NORTH BURNETT
REGIONAL COUNCIL

22 December 2020

CONCURRENCE AGENCY RESPONSE
323 MUNDUBBERA DURONG ROAD, BOYNEWOOD
(Given under section 56(4) of the *Planning Act 2016*)

Application number:	DA200175
Proposed development:	Development Permit for Building Works

SHEET NAME:
SITE PLAN

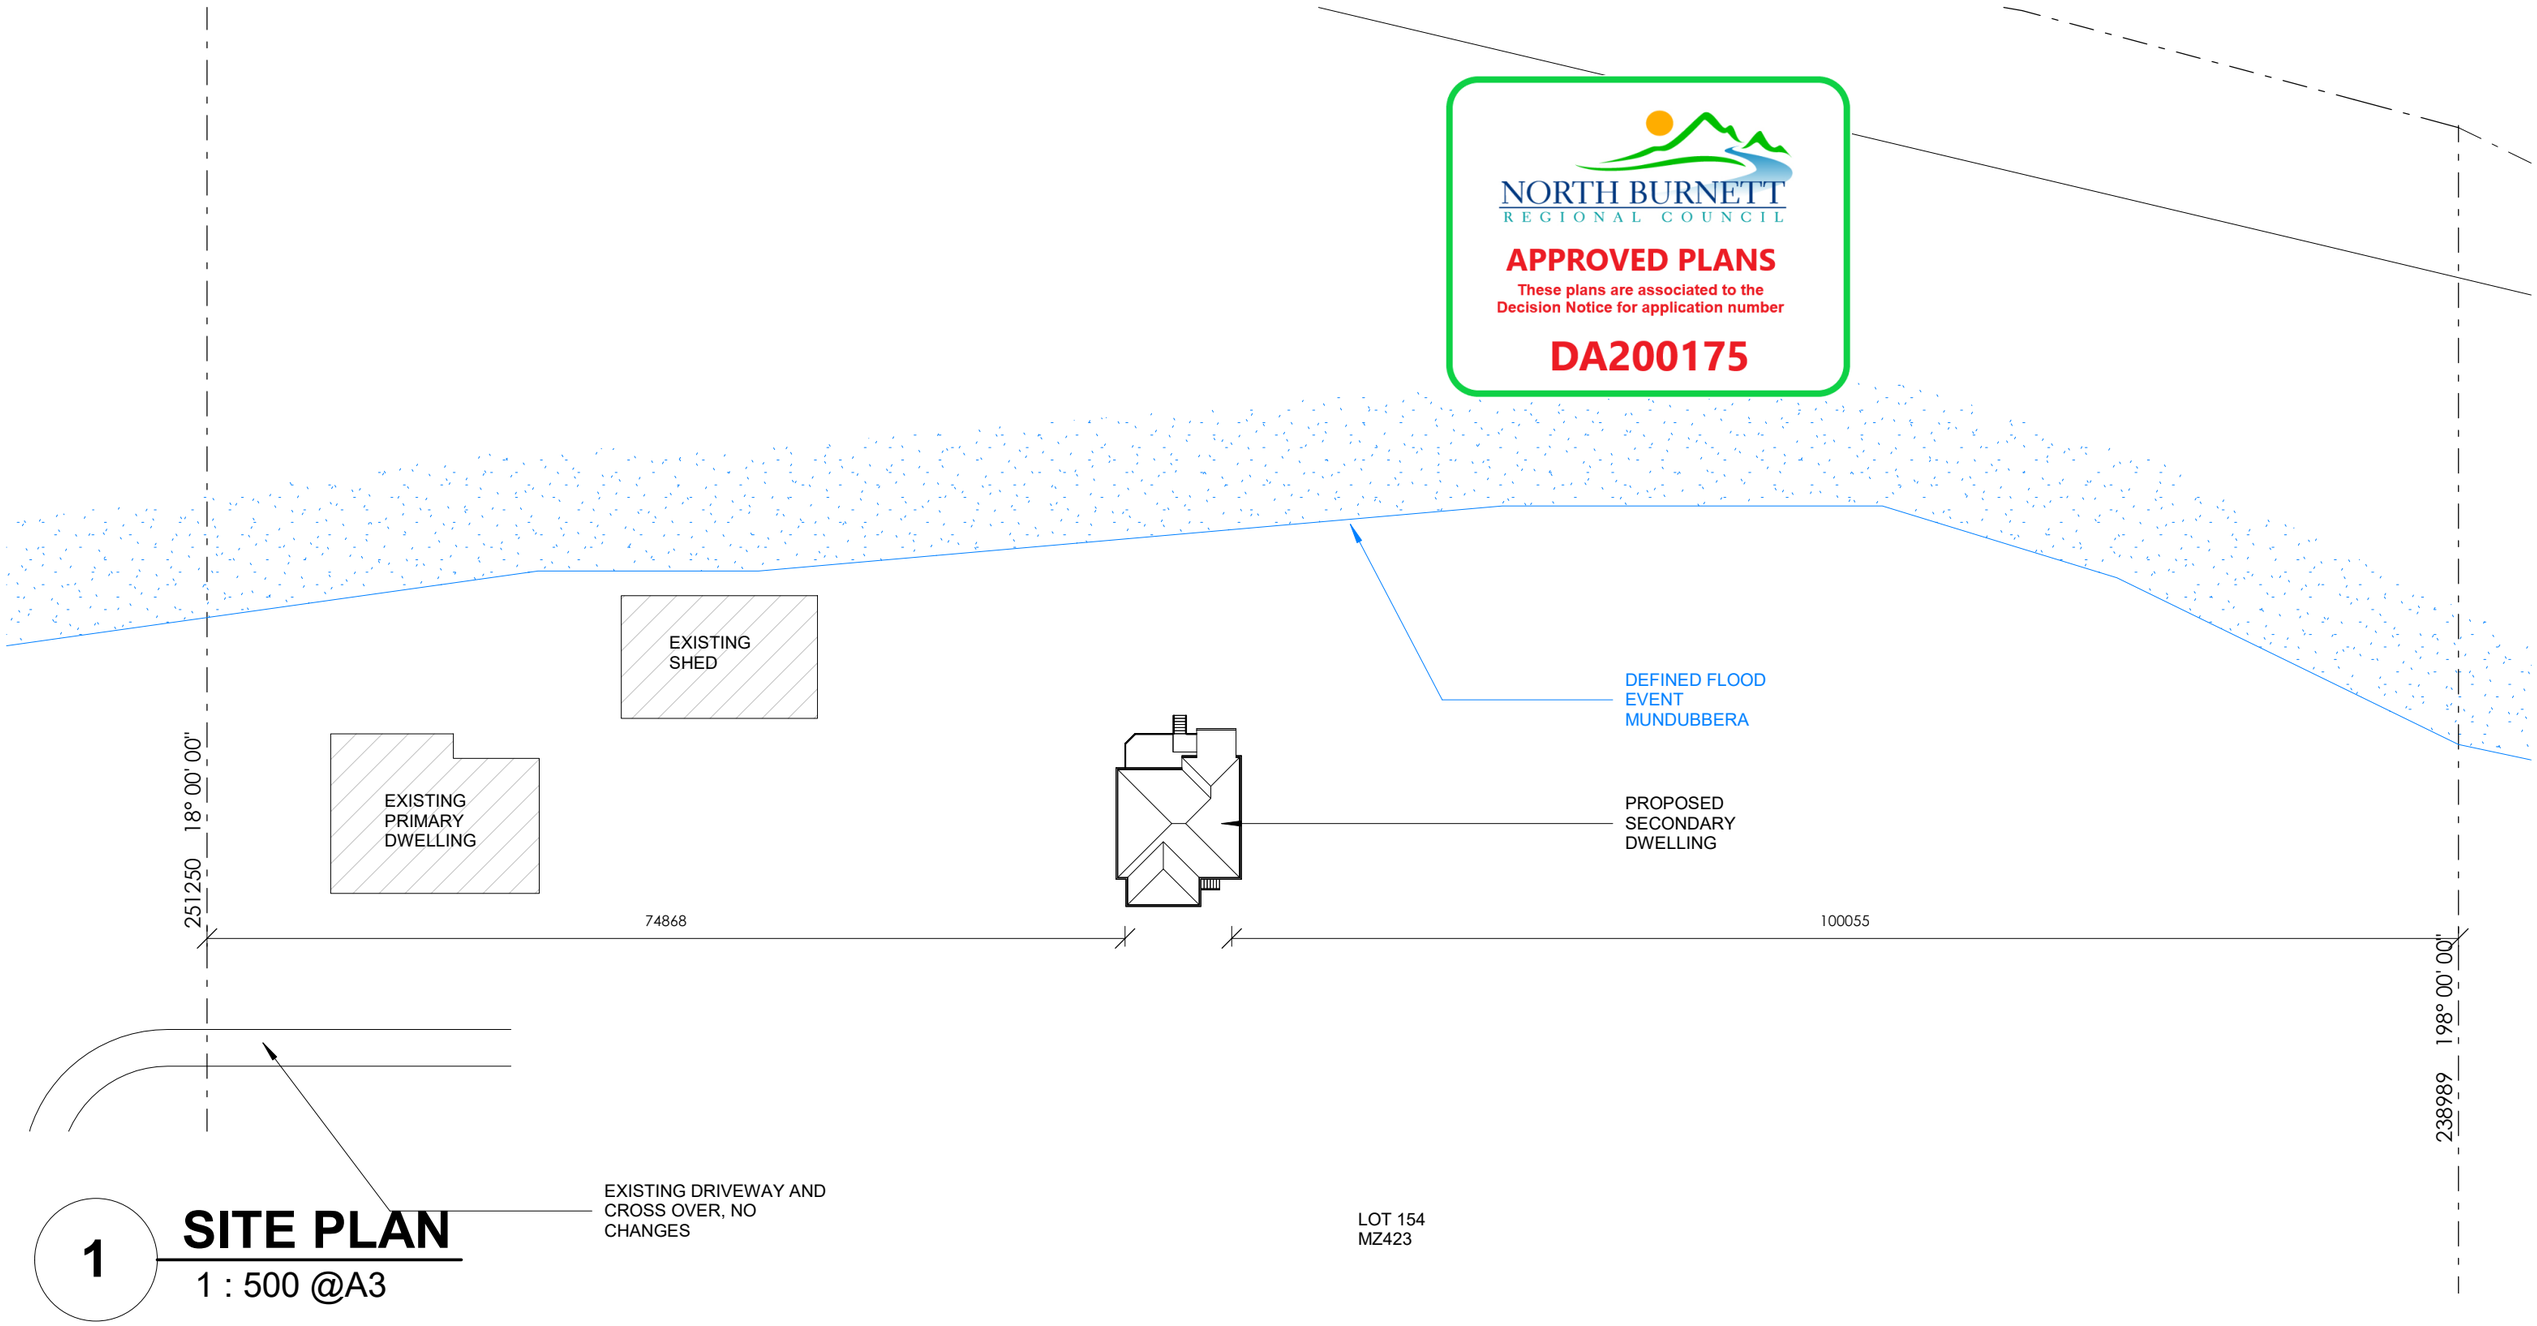
2.	The approved removal dwelling must be sited a minimum: • 150 metres from the Boondooma Road (southern side); • 70 metres from the Mundubbera-Durong Road (western side); and • 100 metres from eastern property boundary, with all setbacks measured from the outermost projection of the structure.

SHEET NAME:
PROPOSED FLOOR PLAN

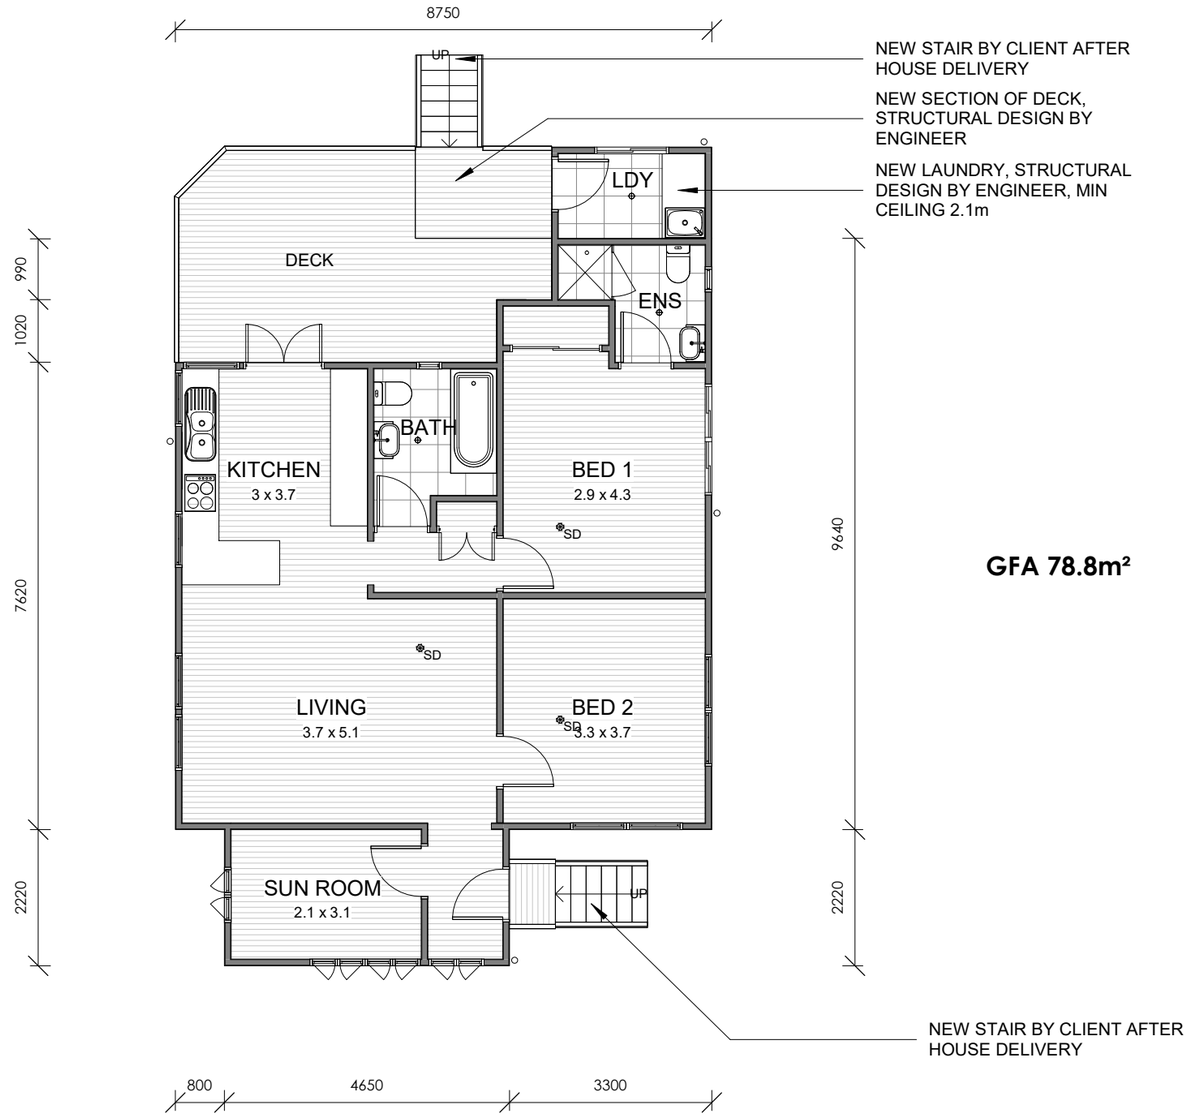
3.	The floor area of the approved removal dwelling must not exceed 80m^2
4.	The height of the approved removal dwelling must not exceed the height above natural ground shown on the endorsed plan. Any earthworks required for the development must be undertaken in such a way as to ensure that the height of the building complies with this condition.
